AGENDA
DESIGN COMMISSION
Buechner Room, 1st floor
Arlington Heights Village Hall, 33 S. Arlington Heights Rd.
Arlington Heights, IL 60005
September 30, 2025
6:30 PM

MINUTES OF THE VILLAGE OF ARLINGTON HEIGHTS DESIGN COMMISSION

ARLINGTON HEIGHTS MUNICIPAL BUILDING
33 S. ARLINGTON HEIGHTS RD.
SEPTEMBER 9, 2025

SITE PLAN - PROPOSED

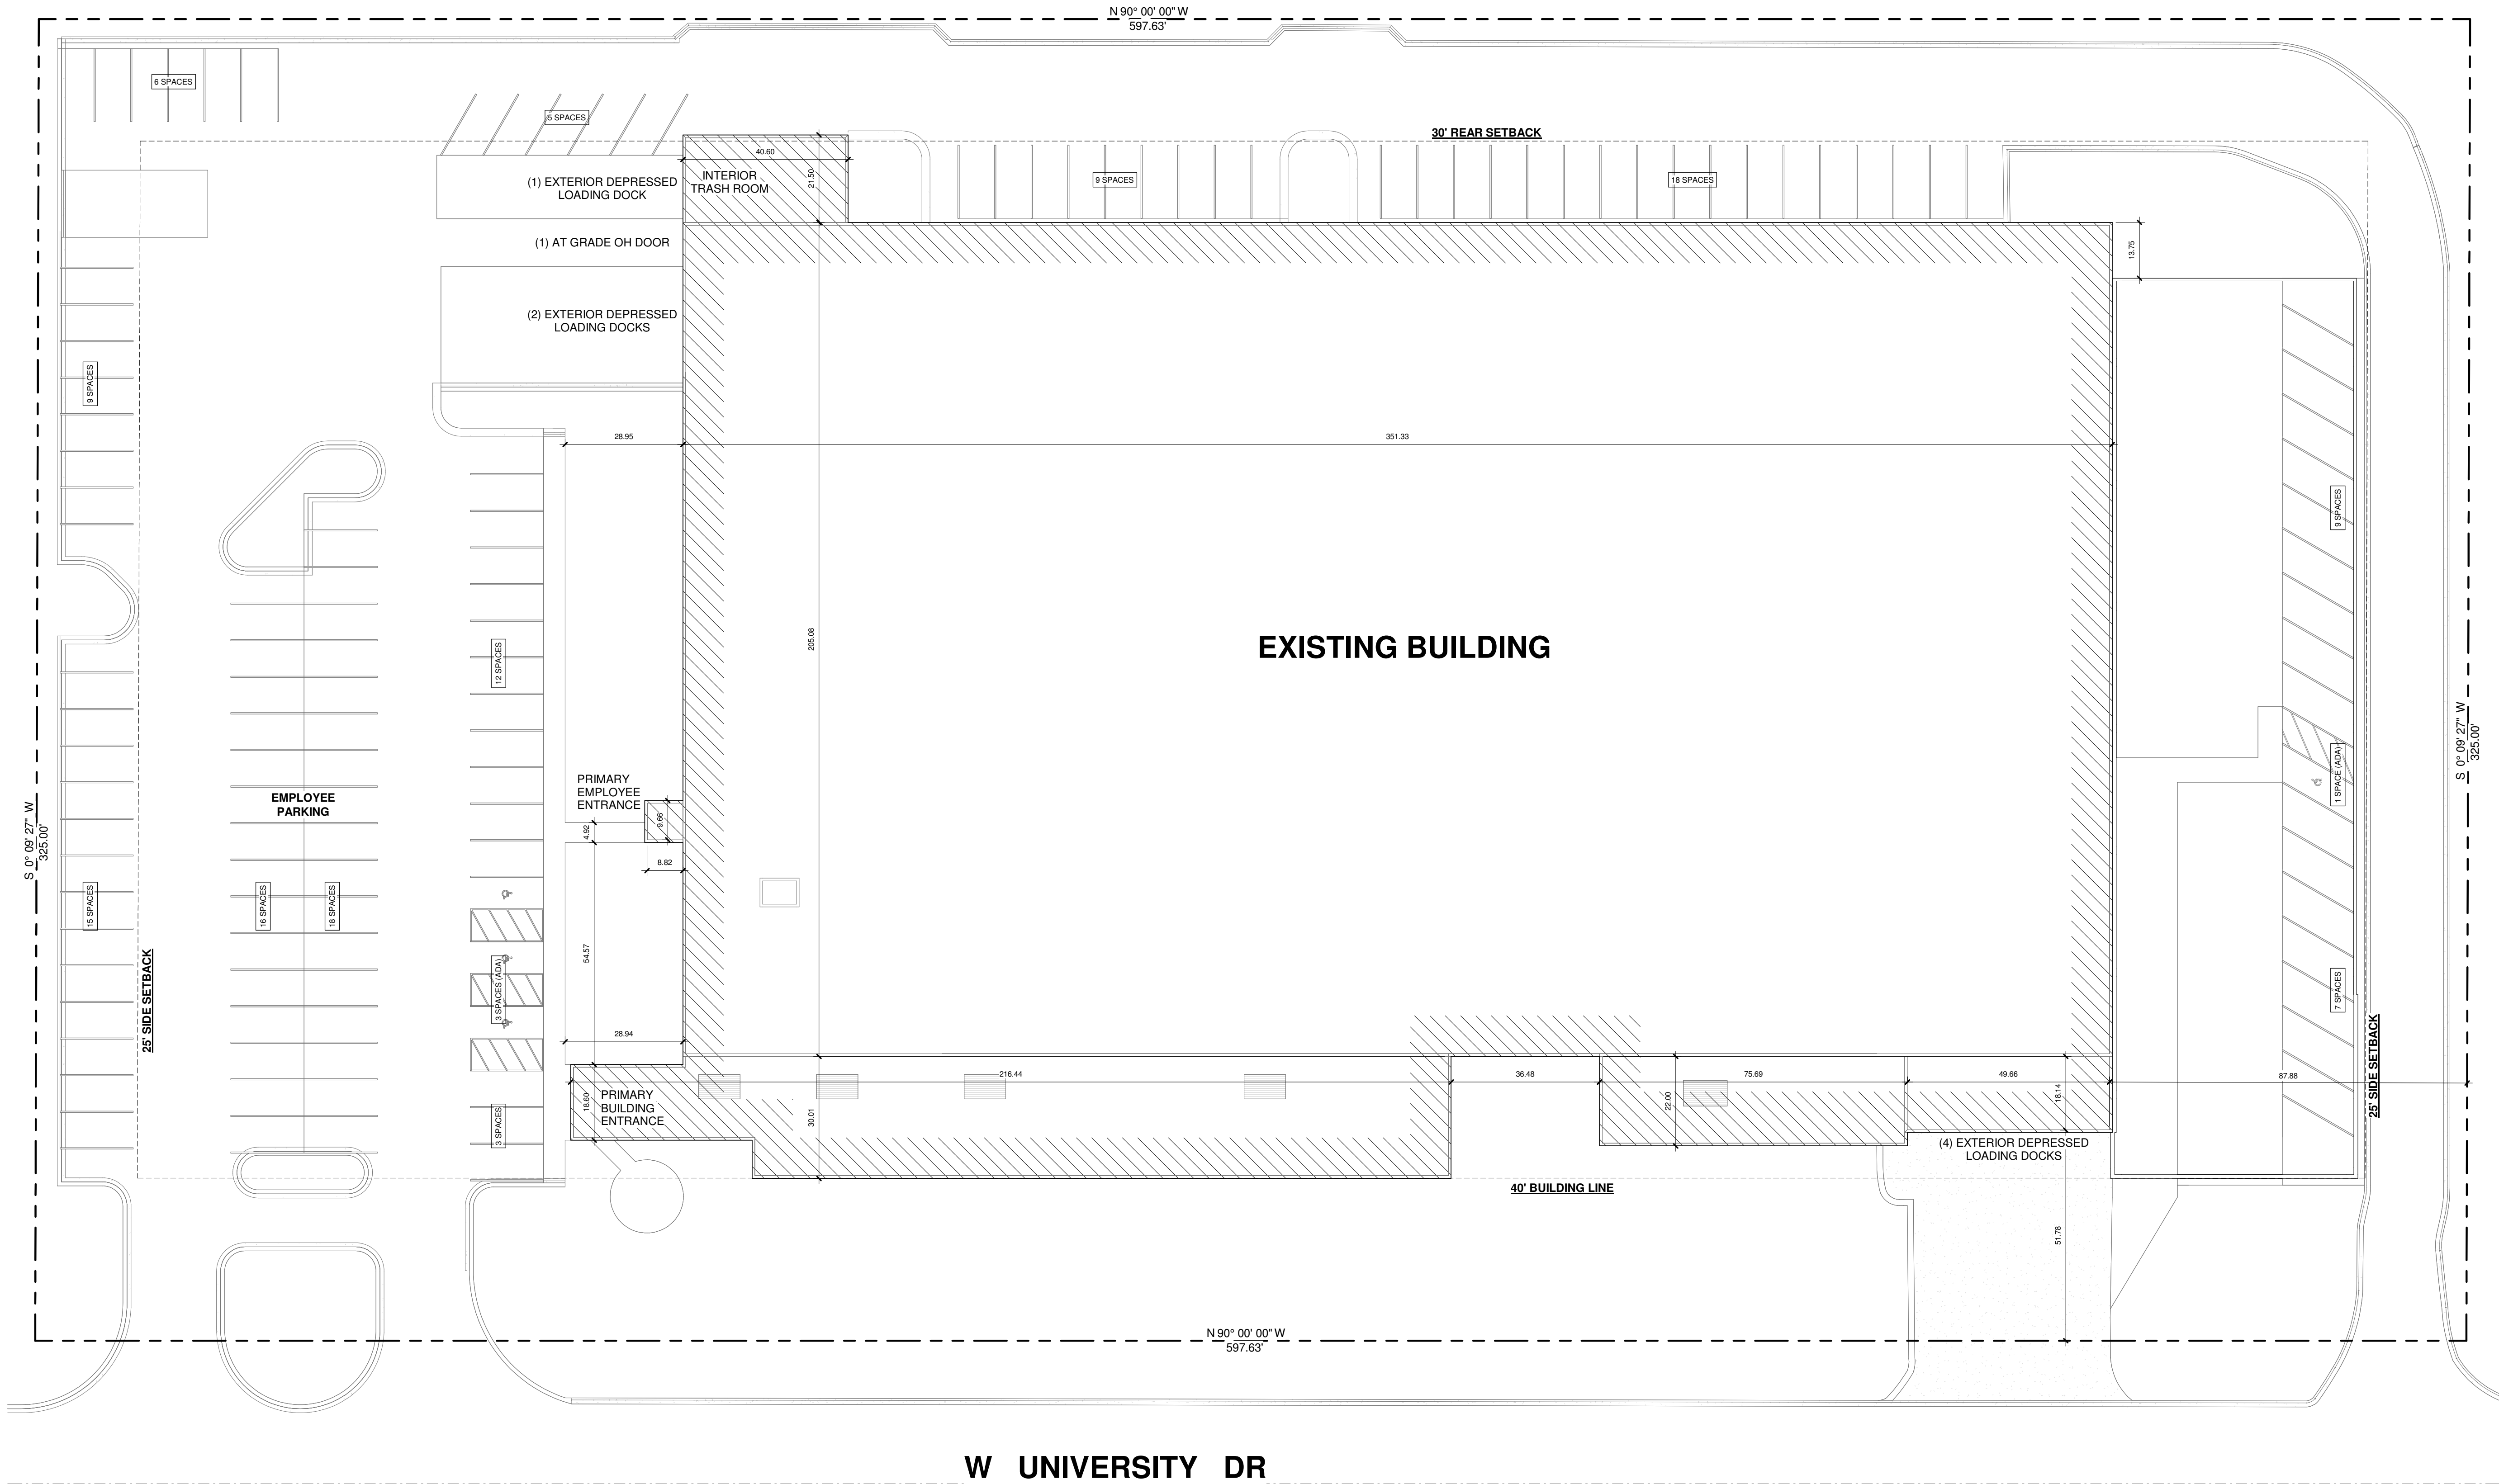
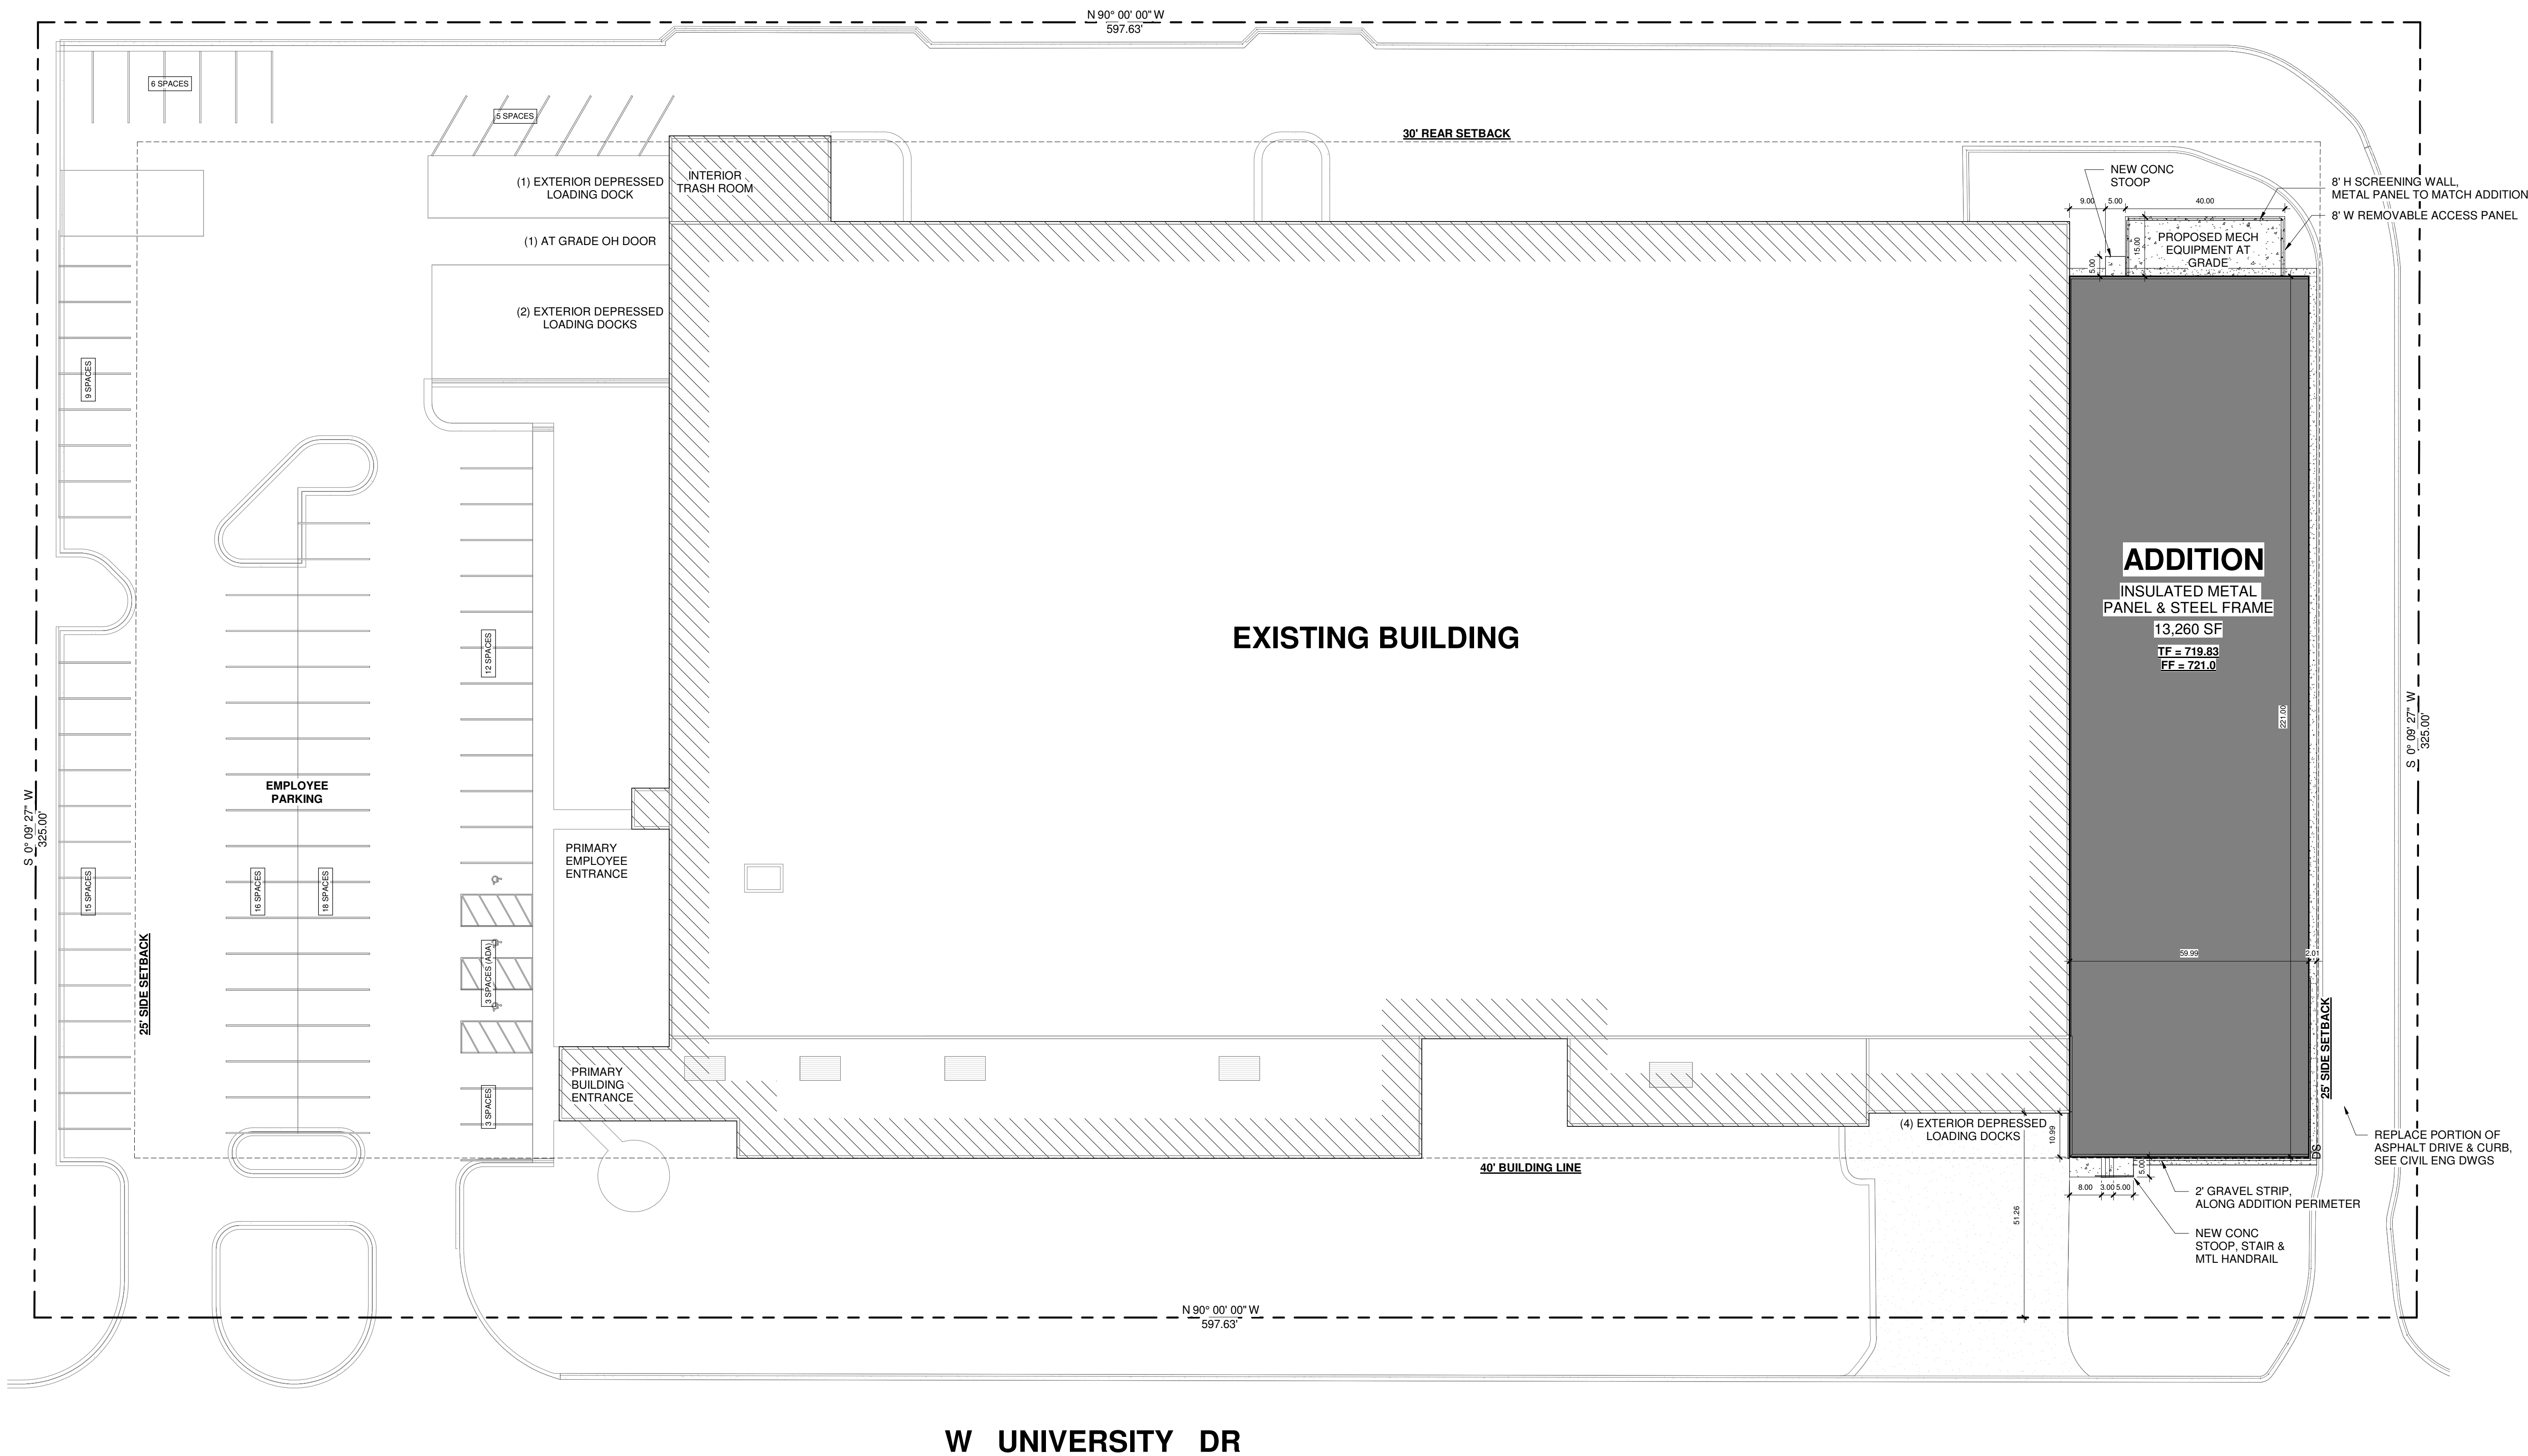
The proposed addition includes a continuous gutter and downspouts along the entire side wall which is undesirable due to the lack of a continuous parapet wall. Staff encouraged the petitioner to incorporate internal roof drains or draining the new addition roof onto the existing roof, both of which the petitioner had concerns with. Another option to consider could be a parapet wall with scuppers instead of the continuous gutter. The Design Commission should evaluate this detail.

SHEET TITLE:
SITE CONSTRUCTION
PLAN

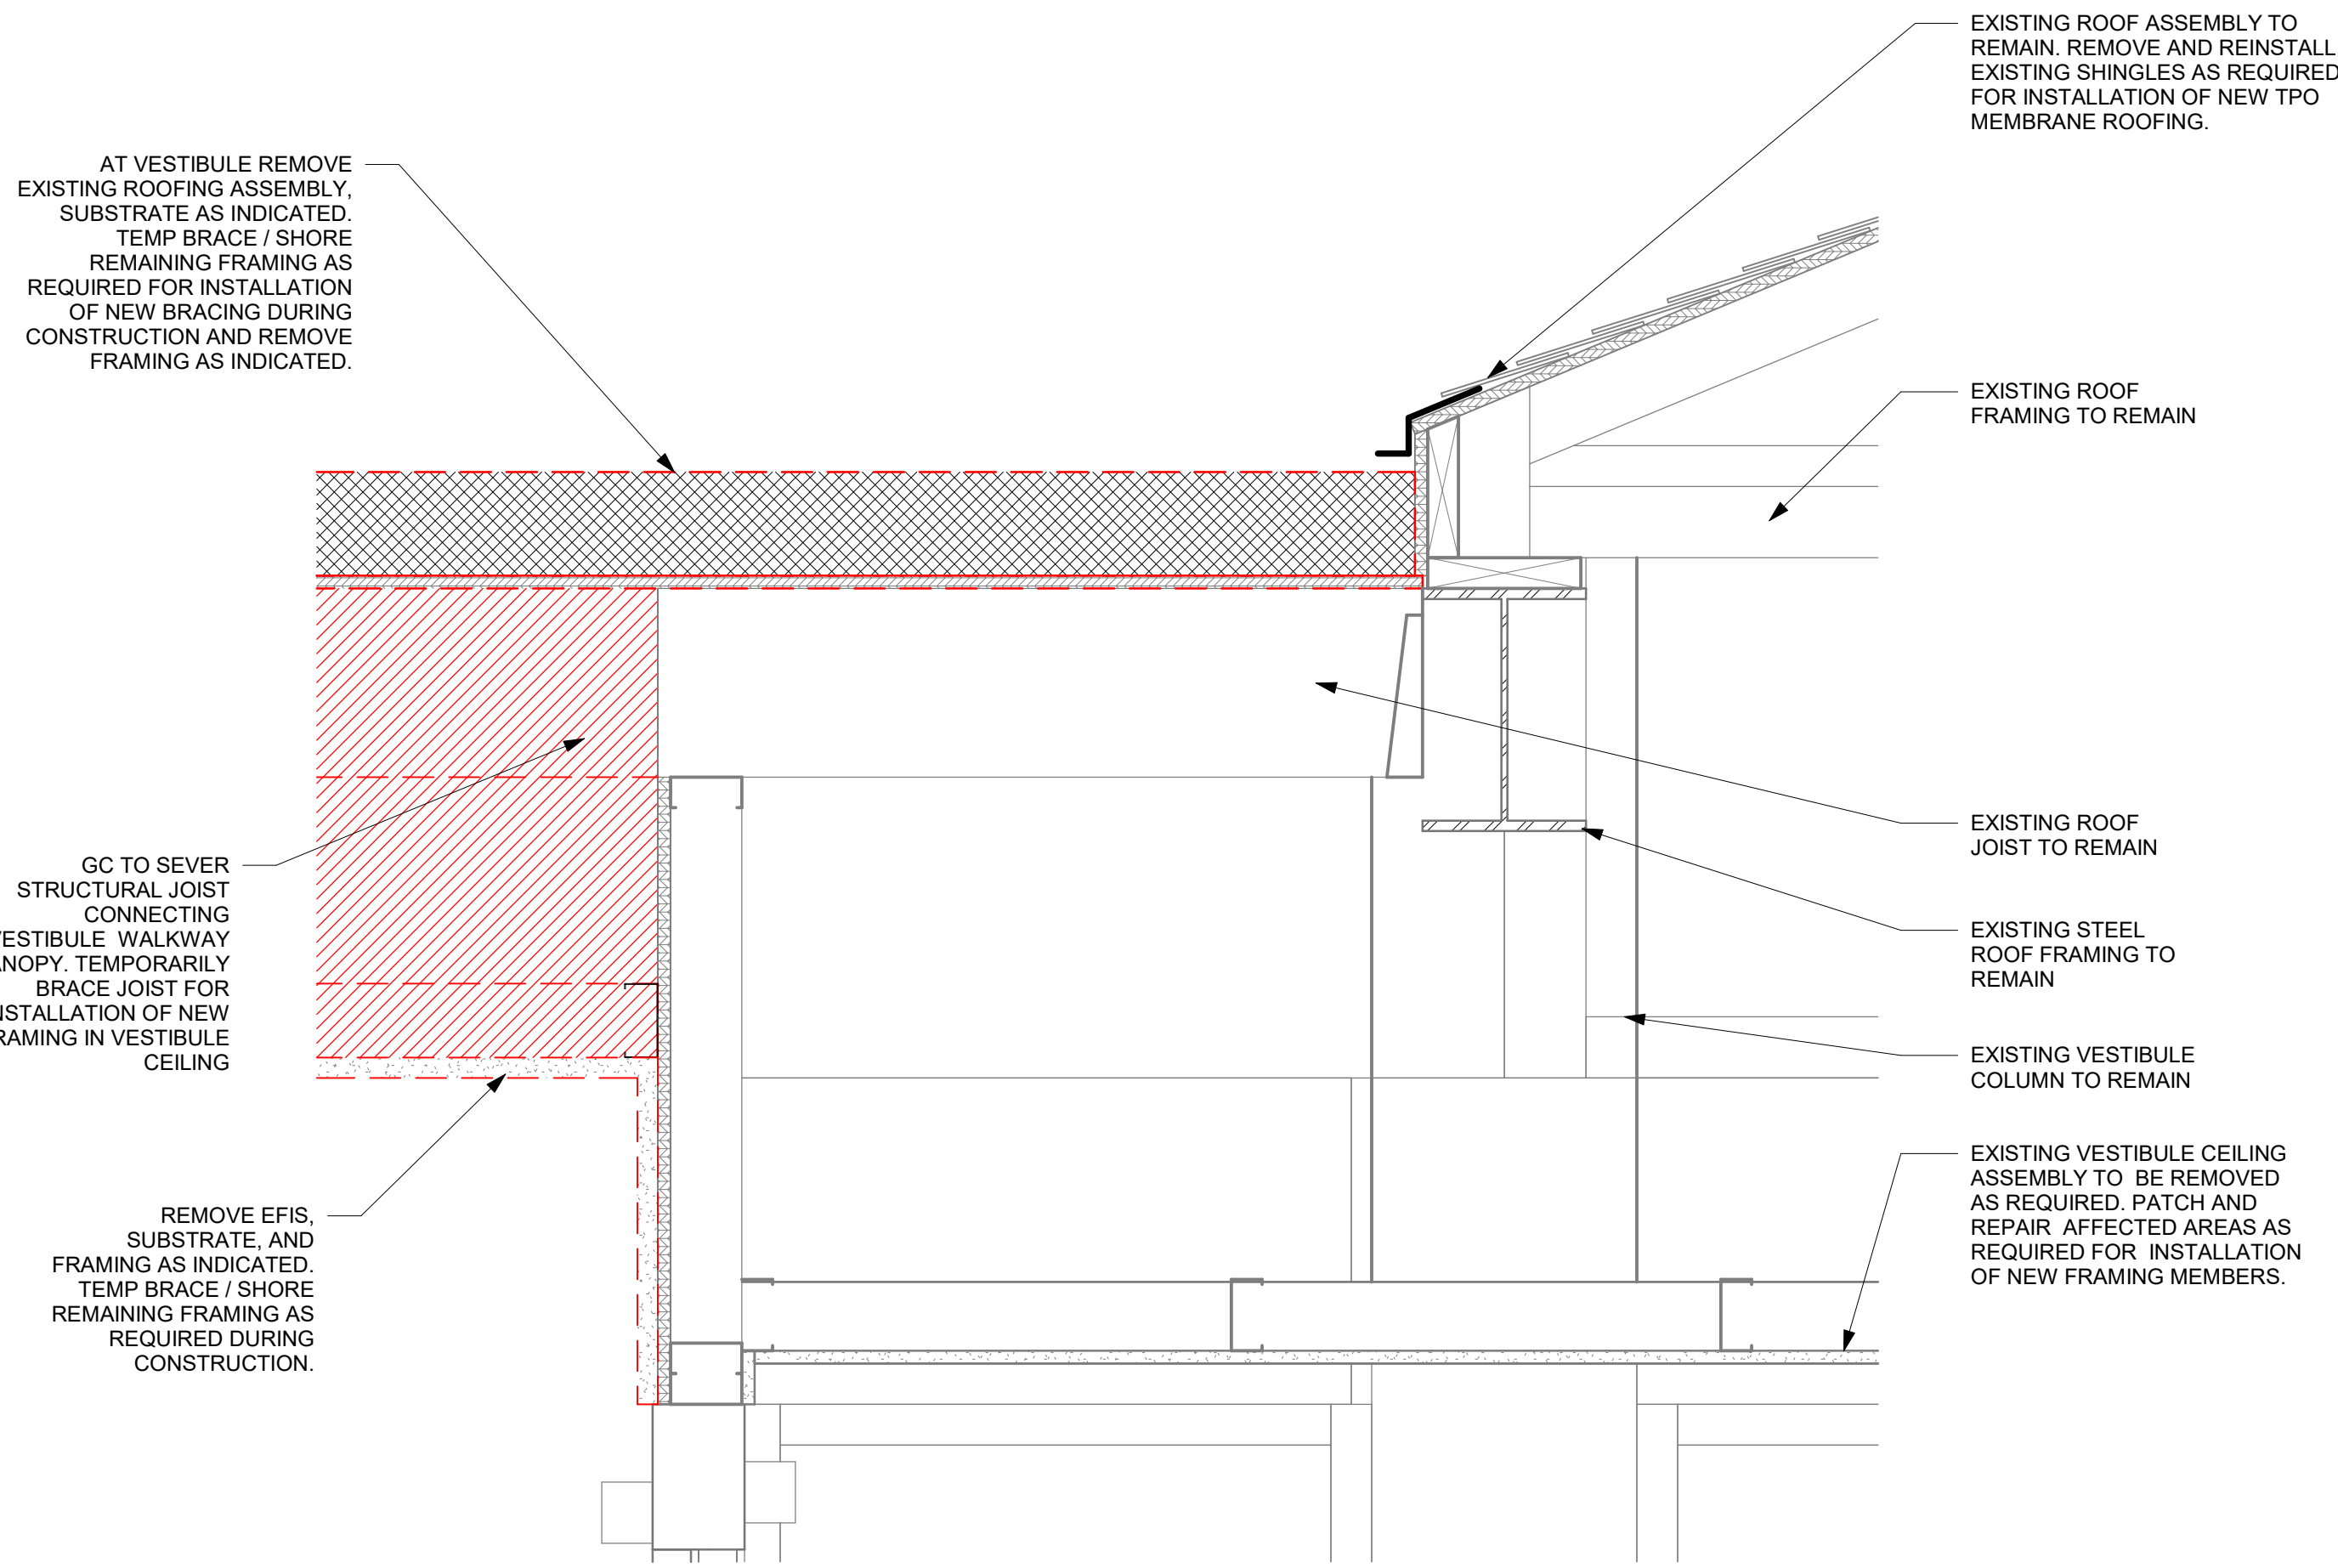
The existing trash storage area is located behind a solid wing wall in the loading dock at the southeast corner of the building. However, the east end of this area is currently open and exposed to view. The current plans include the addition of an opaque fence gate to fully enclose the space and conceal the trash from view.
